Subject: [FIXED] Beam pipe valves?

1) [viewer.gif](#), downloaded 457 times

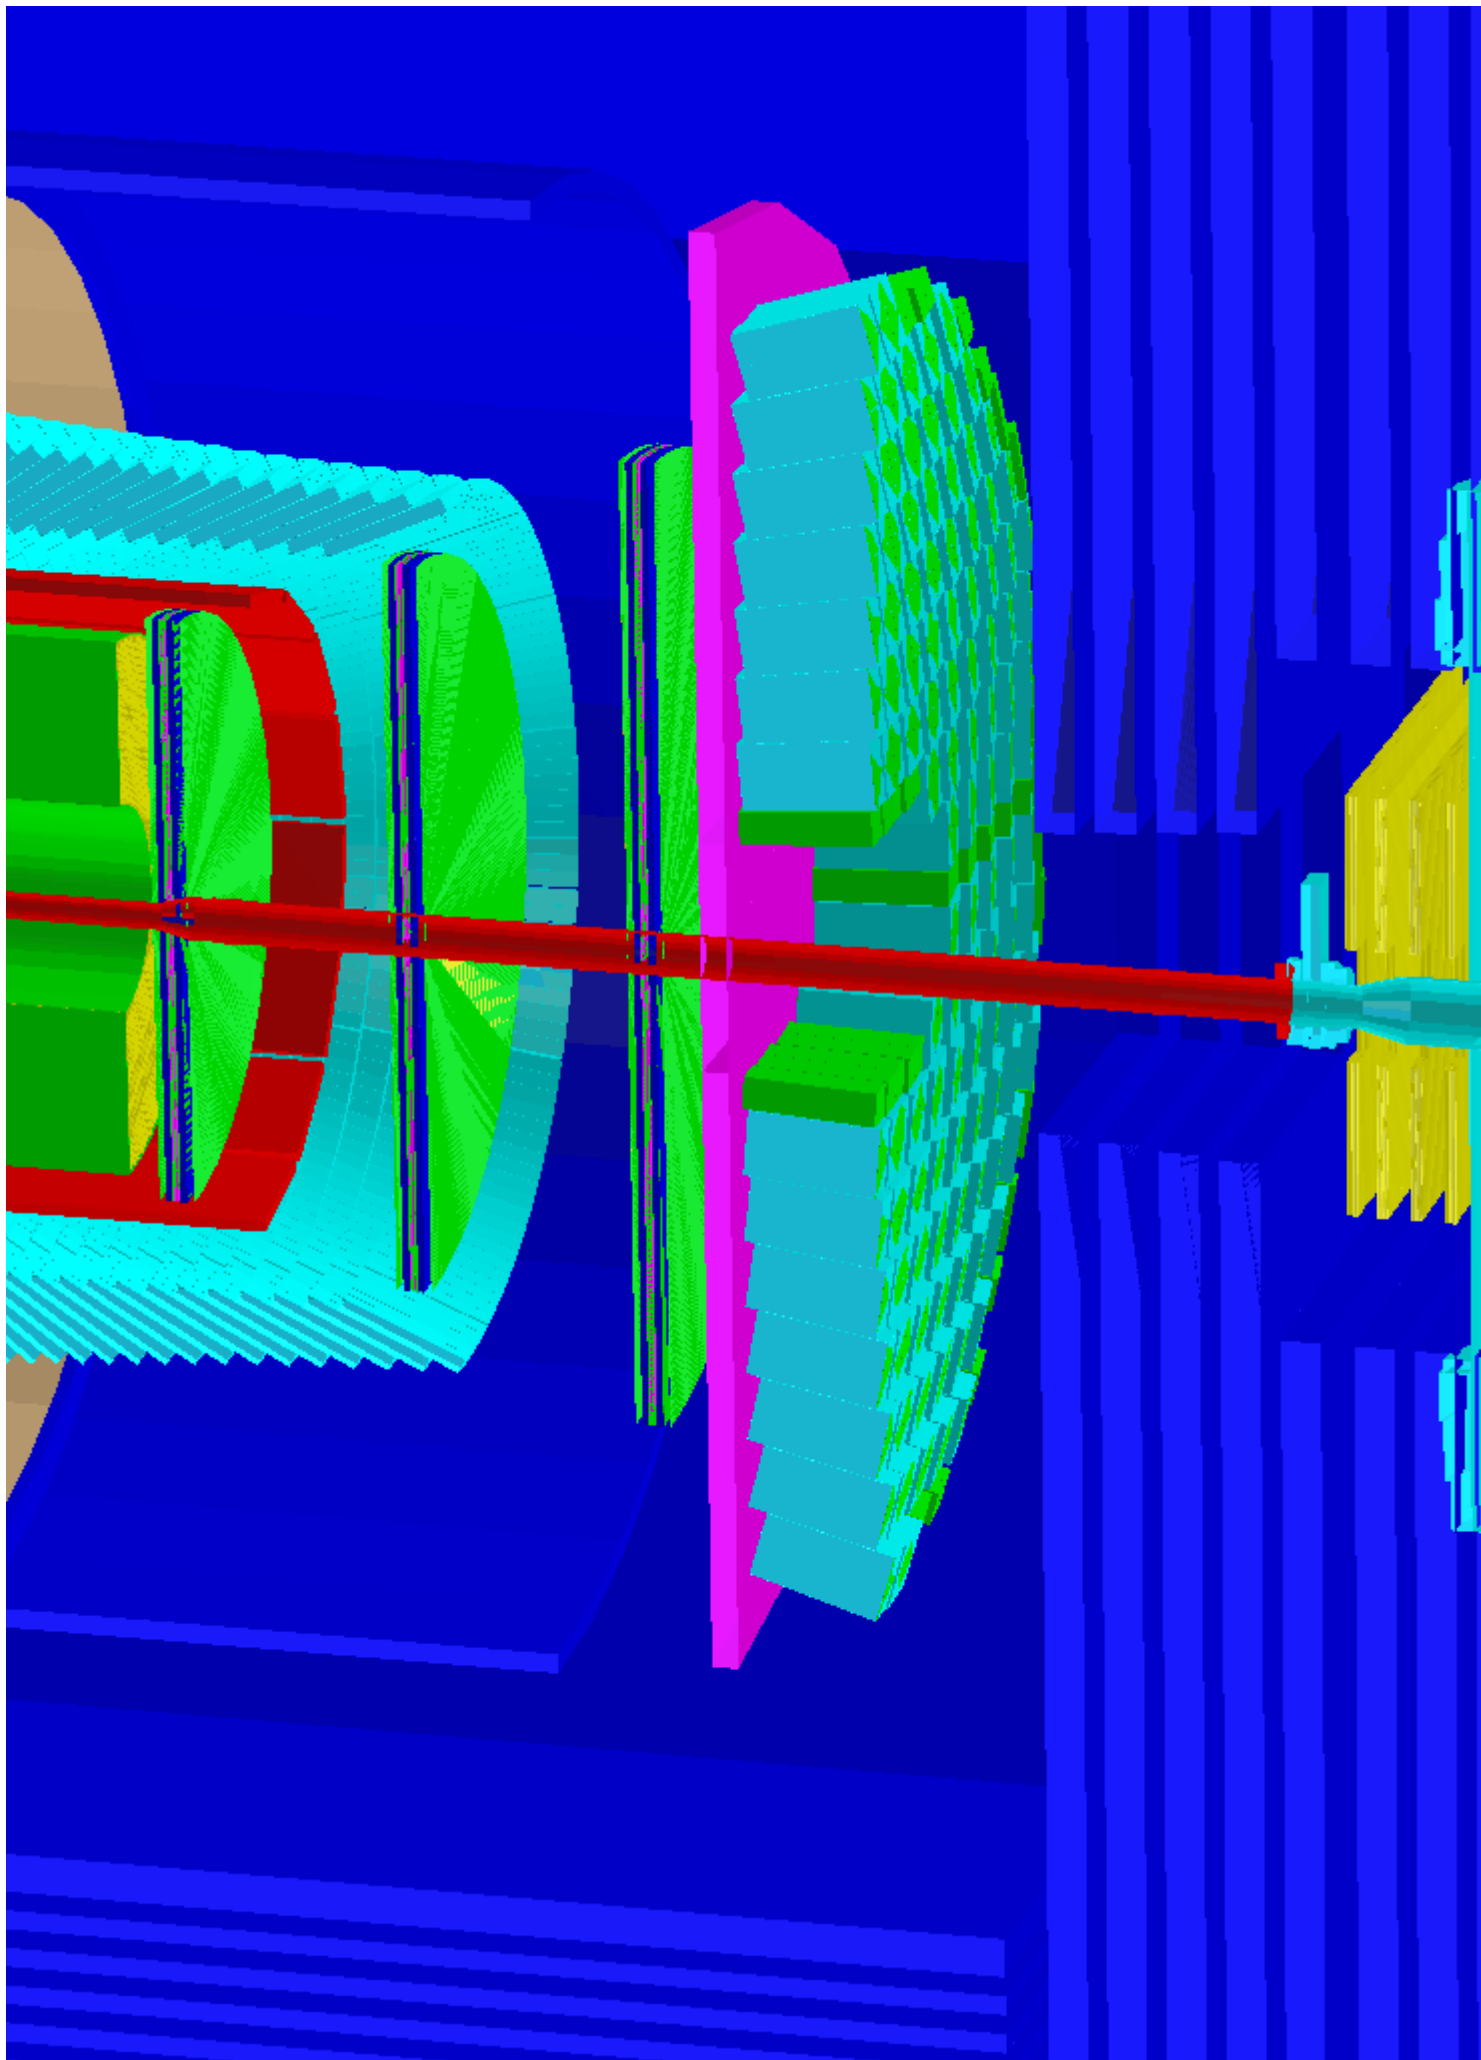
Dear all,
today I plotted the PANDA geometry and I have seen something strange:

In the OGL drawing you can see that the pipe has a sort of "tower" which is in the middle of the muon filter. I am wondering what is wrong there, if the "tower" should be really there, if maybe the muon filter should be modified to host it, or if maybe we have some geometry problems.

Indeed, this is the first pumping station downstream of the target. The description corresponds to what is to be found on EDMS since several years. So I guess that muon description is not up to date?

Fixed!

Please update your mdt folder, in particular those running analysis on forward tracker.
